Application for Works Approval

Works Approval Number	W6693/2022/1
Applicant	Gascoyne Resources Limited
ACN	139 522 900
File number	DER2022/000185
Premises	Dalgaranga Gold Project M59/749 DAGGAR HILLS 6638 WA As defined by the premises maps attached to the issued works approval
Date of report	31 August 2022
Decision	Works approval granted

Appendix 1: Summary of DMIRS geotechnical review summary

Appendix 2: Summary of applicant's comments on risk assessment and draft conditions

Figure 7: Existing and proposed groundwater monitoring bore and VWP locations

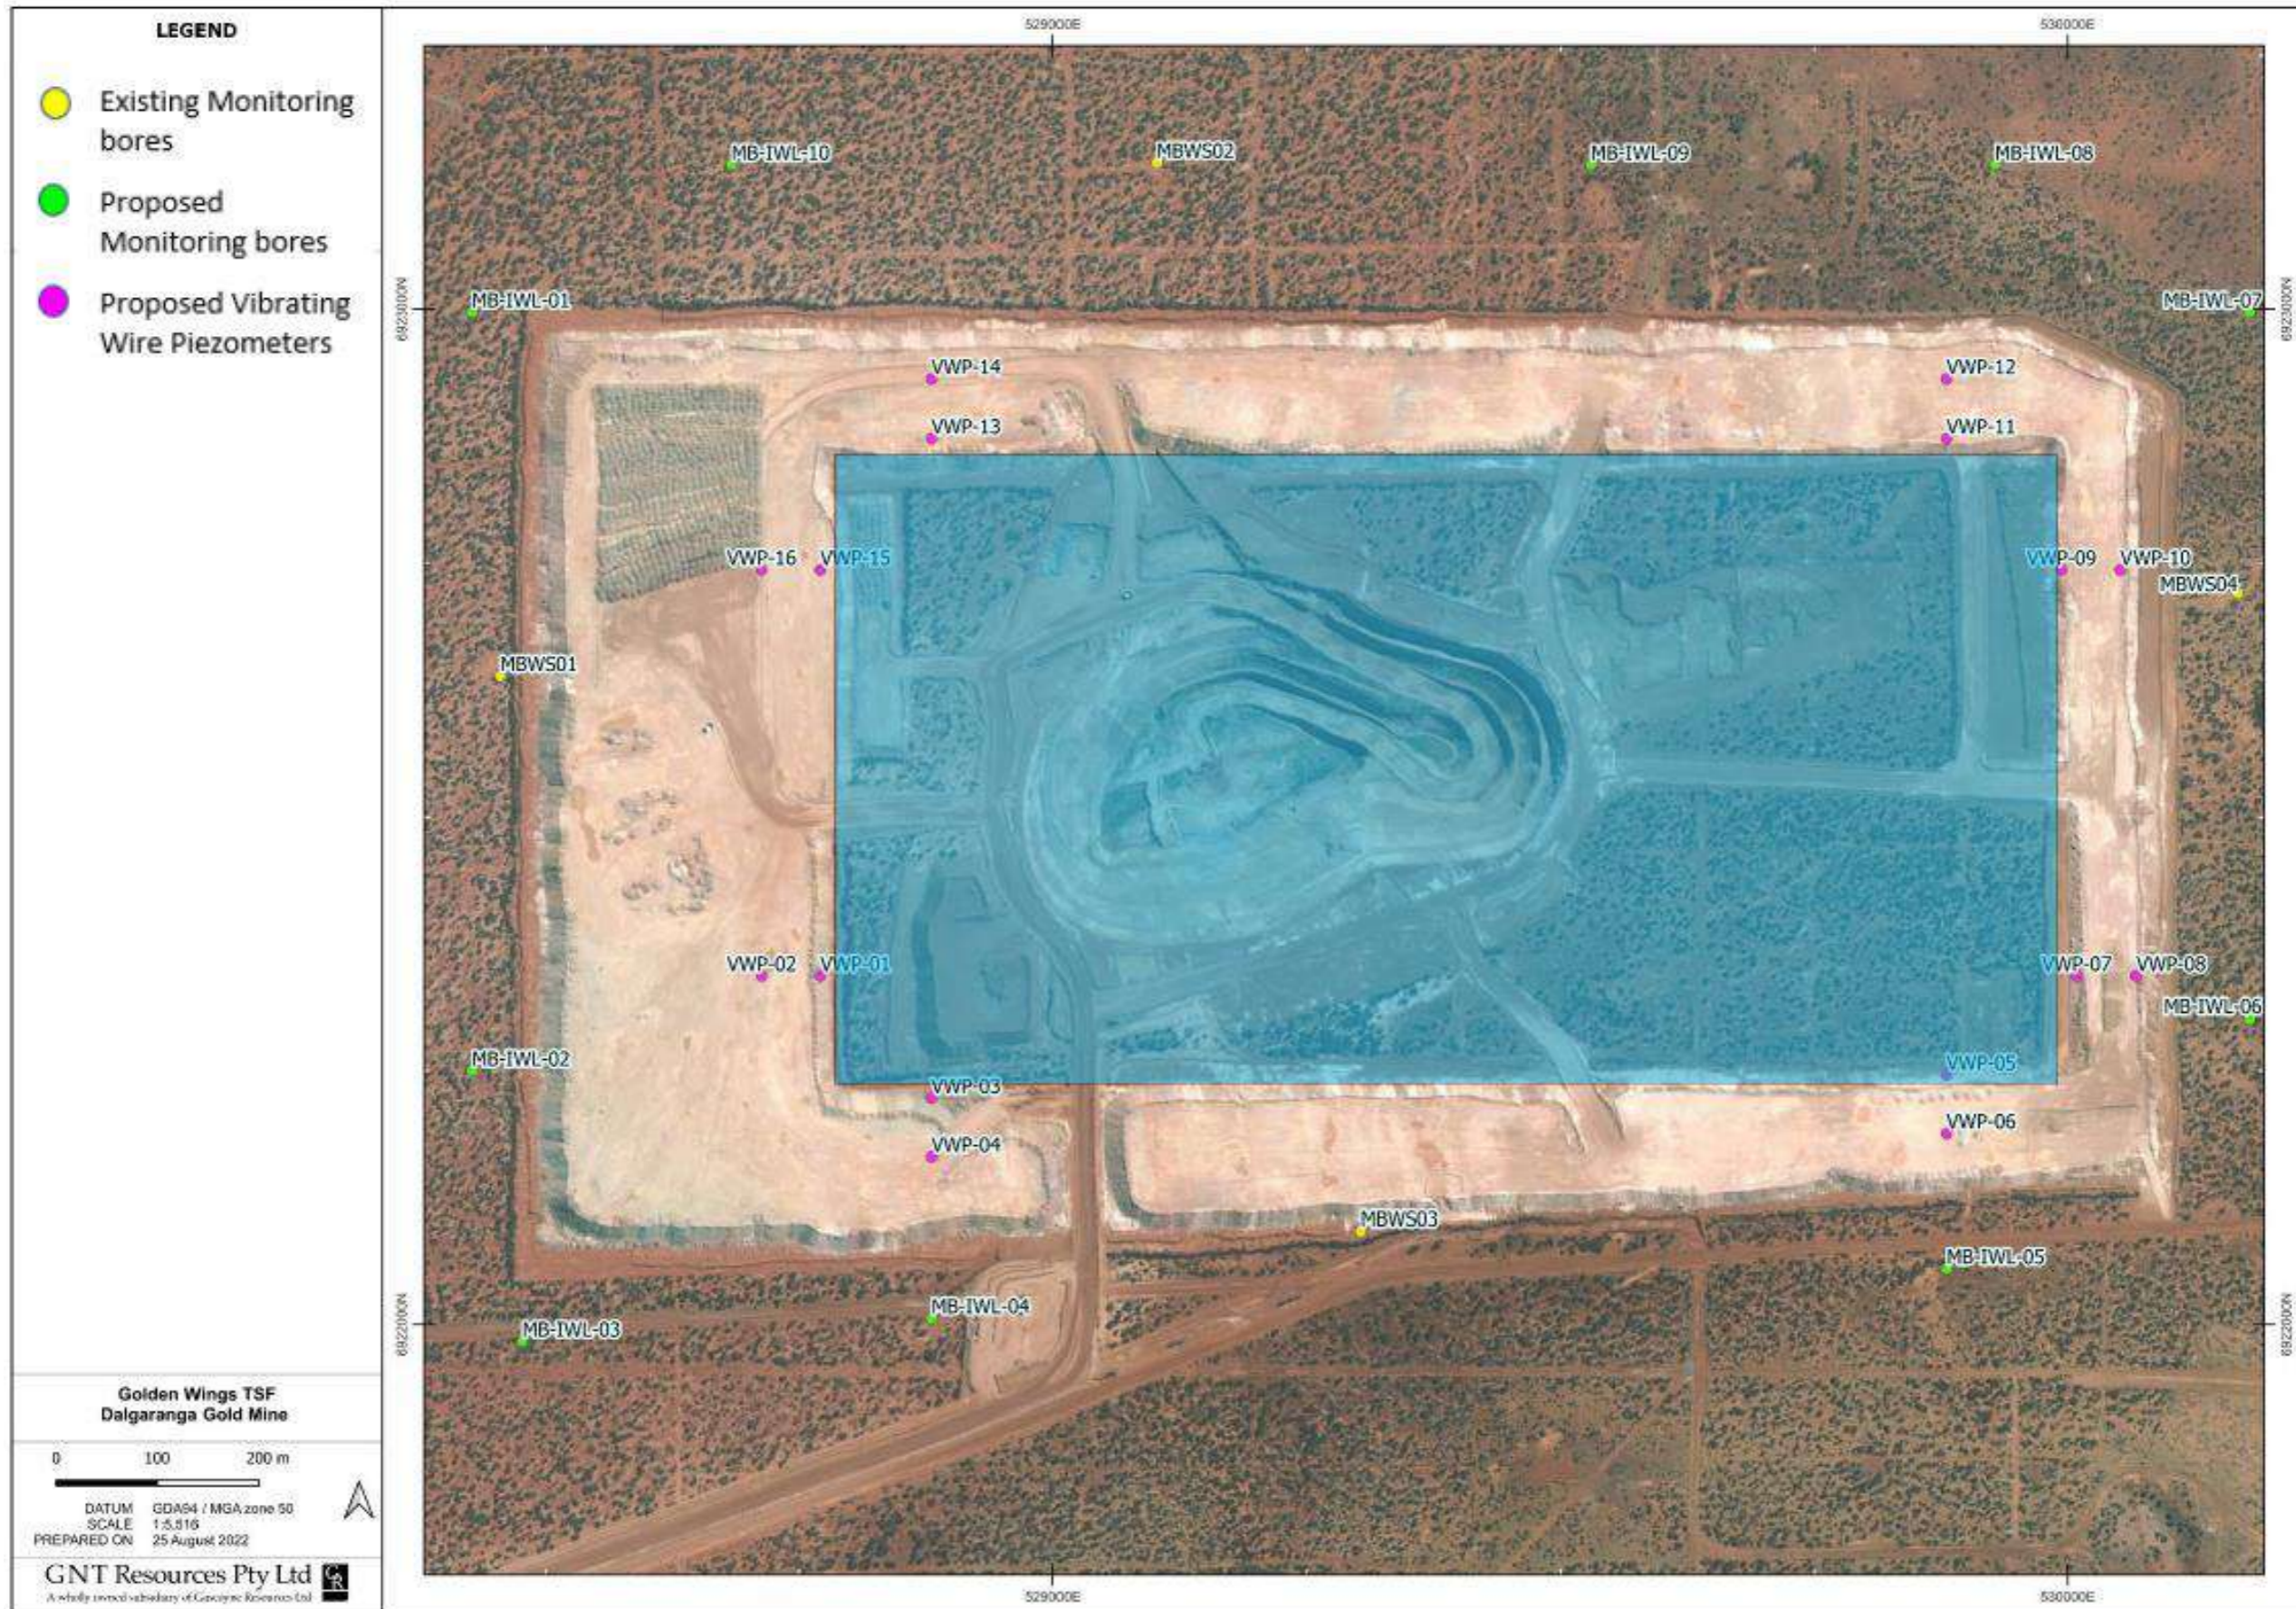
Condition / Section	Summary of applicant's comment	Department's response
Works Approval		
Condition 1, Table 1	Table 1 – dot point 2. For all stages of the dam, a geotextile layer (approximately 1.5m wide) will be placed under each tailings discharge spigot to prevent erosion of the wall	Updated dot point as per applicant's request.
Condition 1, Table 1	Table 1 Item 10. An updated figure is attached to this document (GWTSF Bores.pdf)	Updated figure 8 with the updated figure provided by the applicant.
Condition 15, Table 6	Table 6 Item 7. VWPs have been included in the updated figure - GWTSF Bores.pdf	As above.
Definitions table	Table 10 Annual Period. A 12-month period commencing from 1 November until 31st October of the immediately following year.	Updated definition to include the specified dates.
Decision Report		
Section 3.1.1, Figure 7	An updated Figure 7 is attached that shows the Golden Wings TSF only (pers comms Licensing Officer), with its monitoring bores and vibrating wire piezometer locations (GWTSF Bores.pdf).	Updated figure 7 with the updated figure provided by the applicant.
